From: Charles E. Brockway [charles.e.brockway@brockwayeng.com]
Sent: Friday, October 07, 2011 9:25 AM
To: Edl, Michele
Cc: Jim Speck; watermanager@cableone.net; Keen, Shelley
Subject: Warfield Hotsprings, SDTR water right license
Attachments: IMG_0727.JPG; IMG_0728.JPG; IMG_0729.JPG; IMG_0730.JPG; IMG_0734.JPG; IMG_0735.JPG; IMG_0736.JPG; IMG_0731.JPG

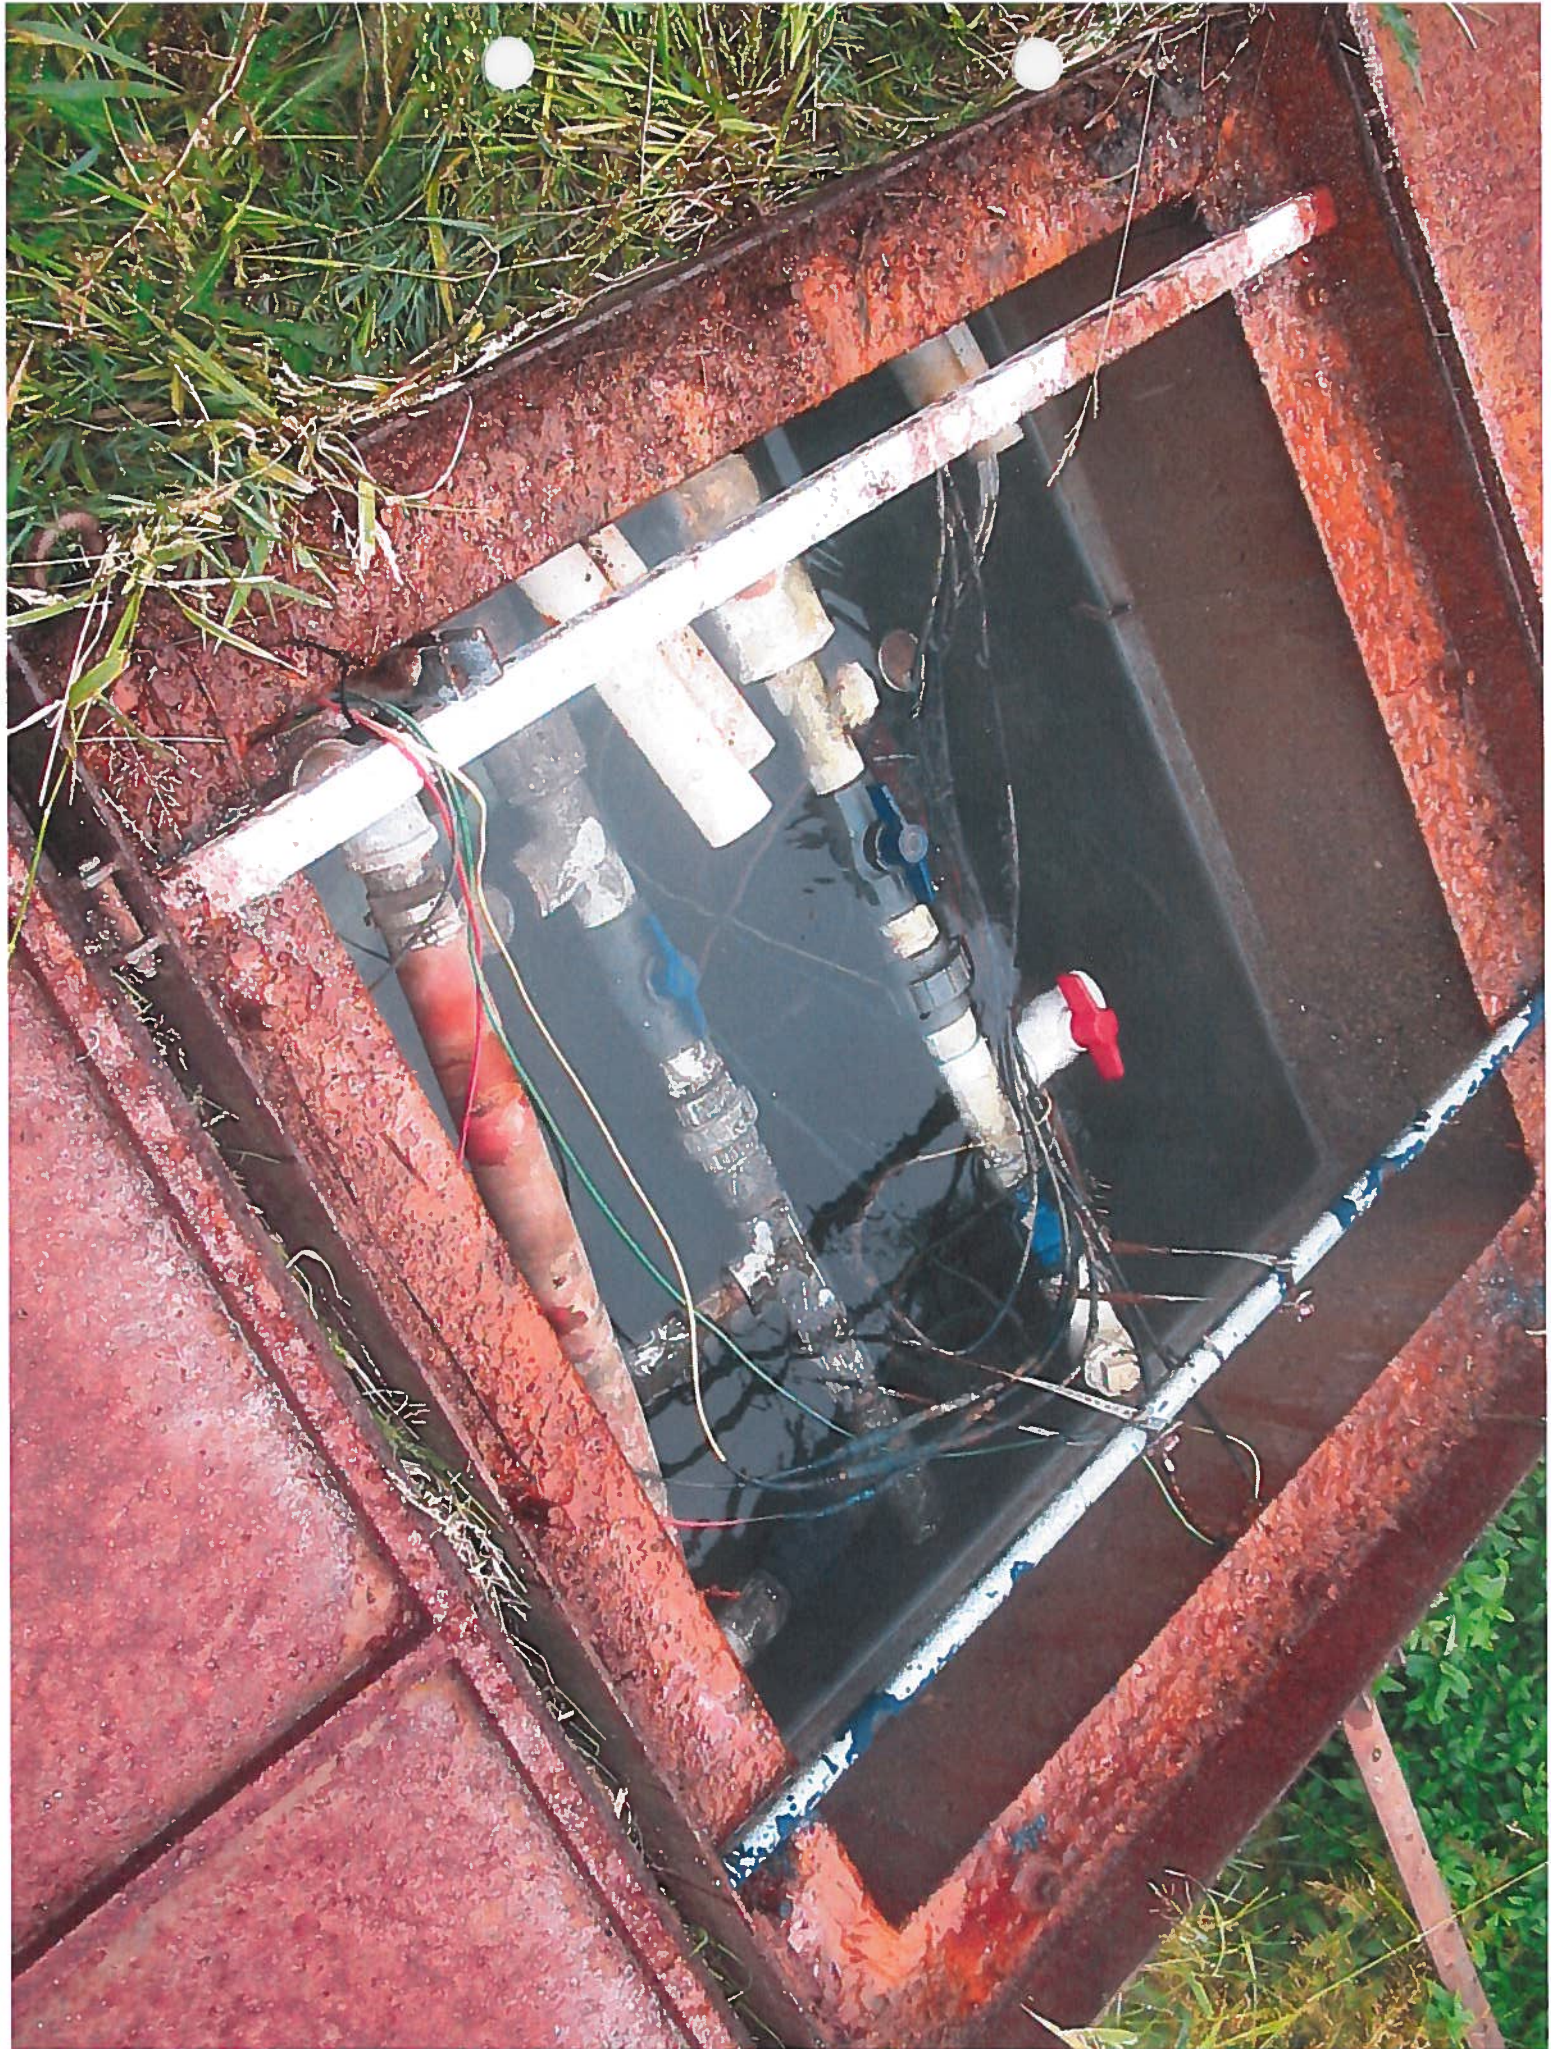
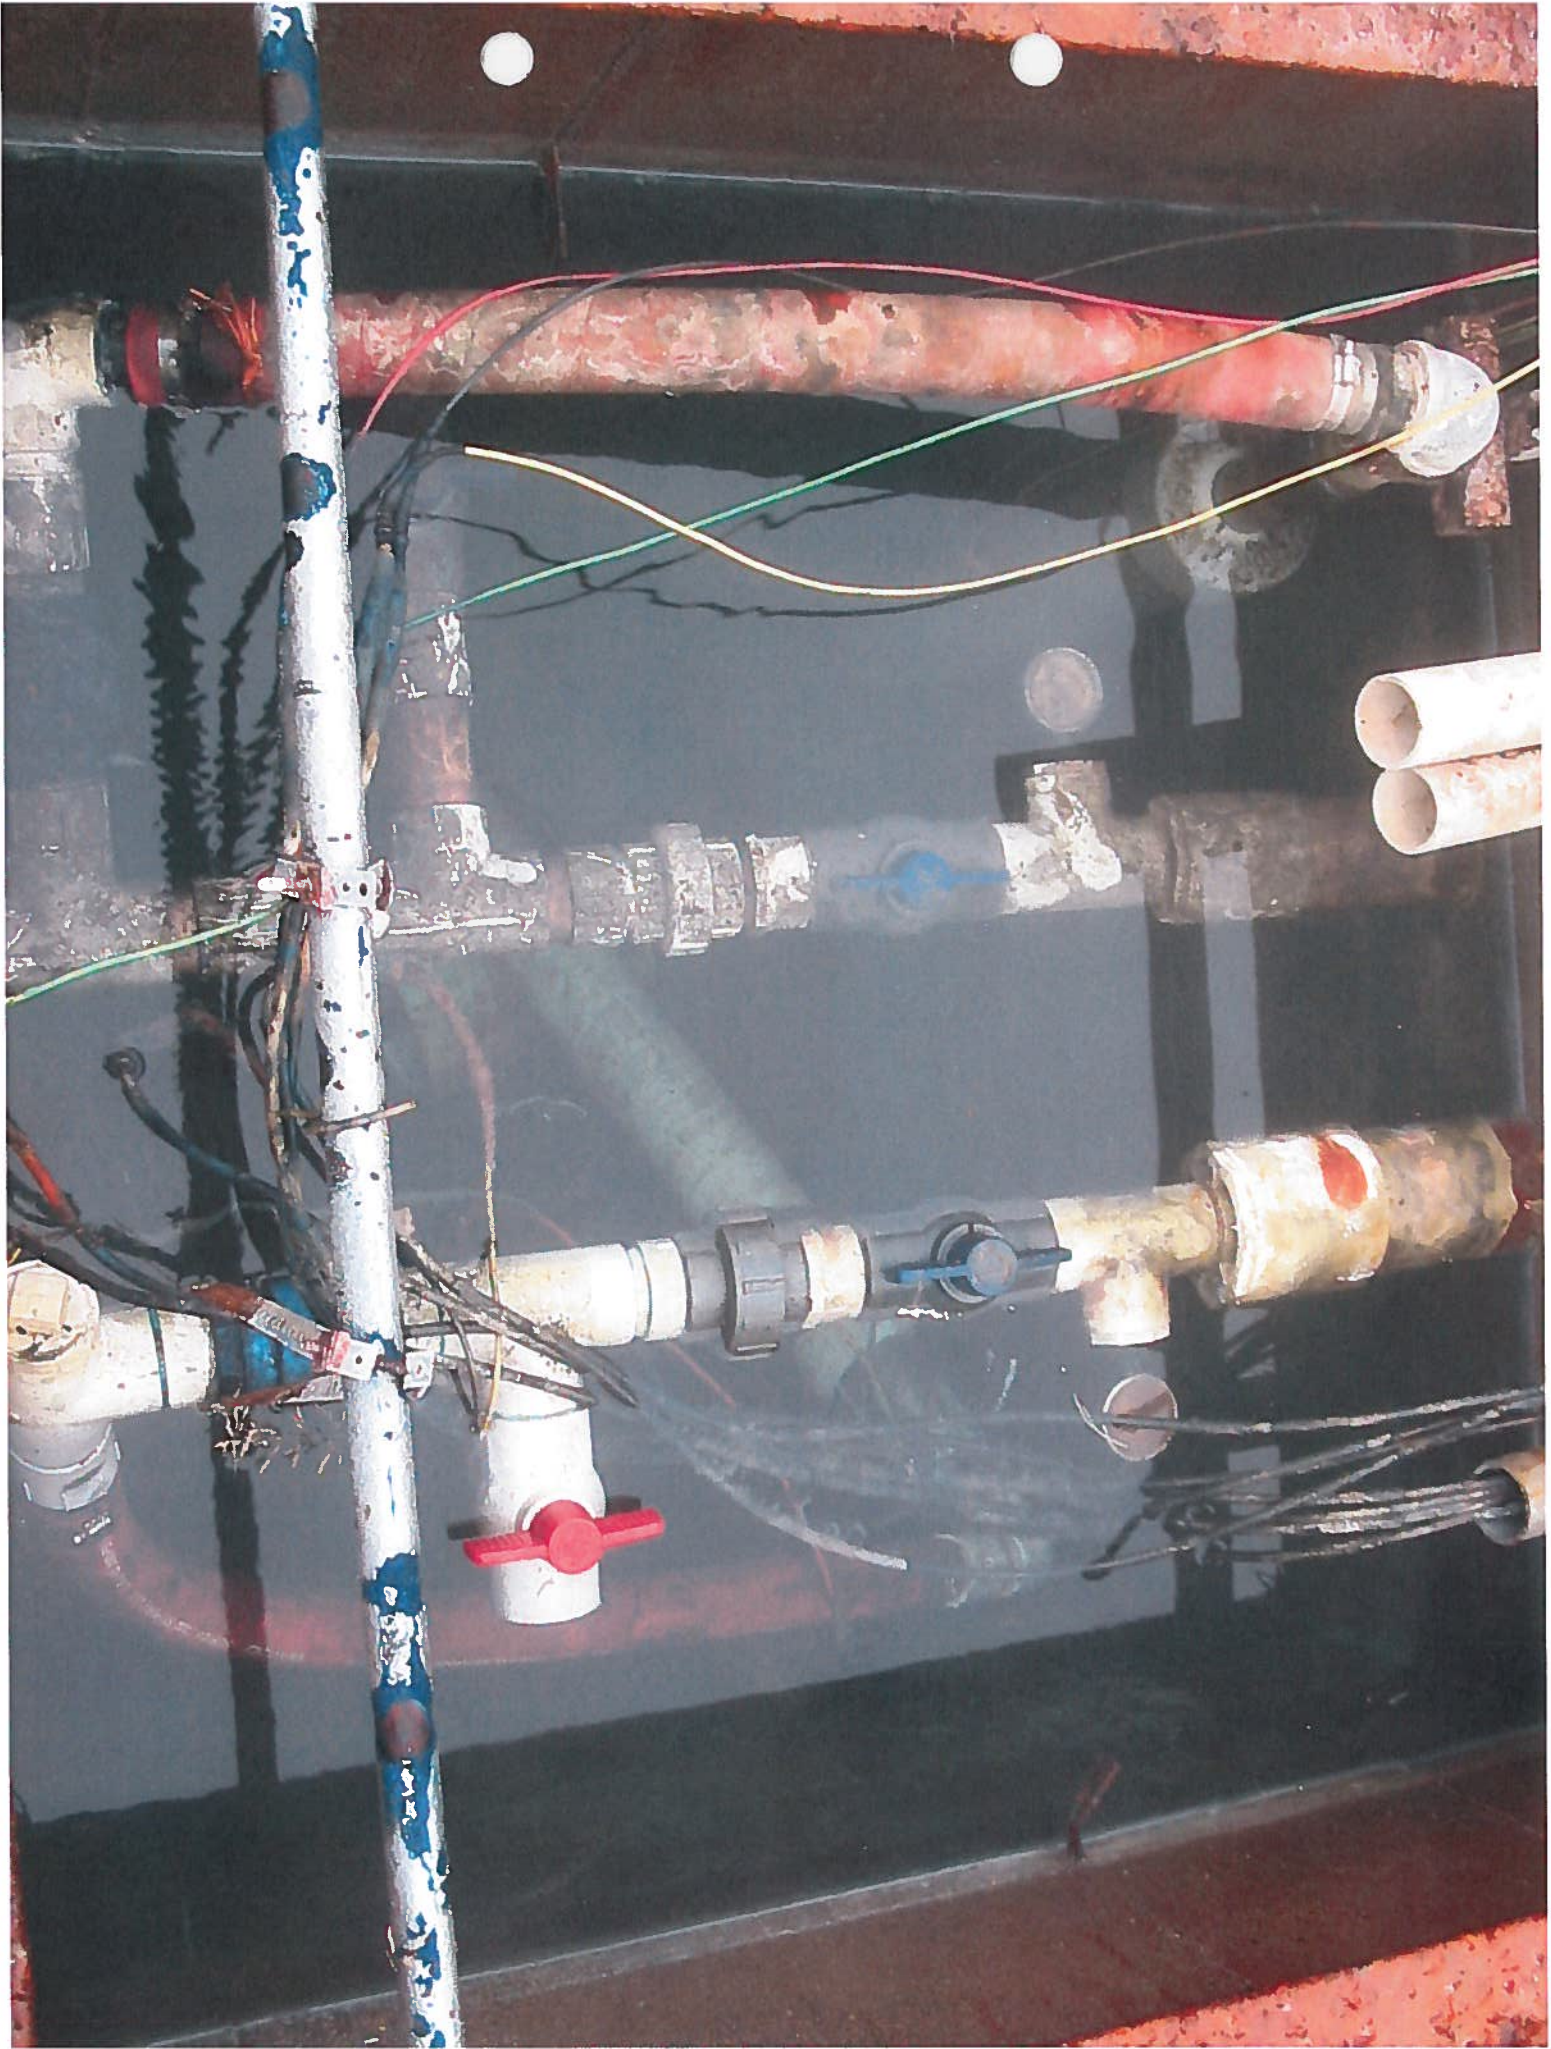
Michele: Attached are photos of the collector sump for the SDTR water right. These photos were taken on October 6, 2011 by David Rosser, manager of the property. The sump collects water from the buried pipe collectors and includes the submersible pump which pumps the geothermal water to the facility. Note there are two ball valves (blue) on the supply lines which go to the flow meter and thence to the facilities. These valves allow adjustment of the discharge but are not lockable. The cover for the sump is a steel lid with a steel strap and padlock hasp as shown on the photos.

It is proposed that the sump supply valves and lockable lid, with a lock and key available to the Watermaster, suffices for the requirement on the proposed license of a 'controllable, lockable headgate'. The alternative is to dig up the supply pipe, valve, and flow meter and replace the valve with a lockable valve of some sort.
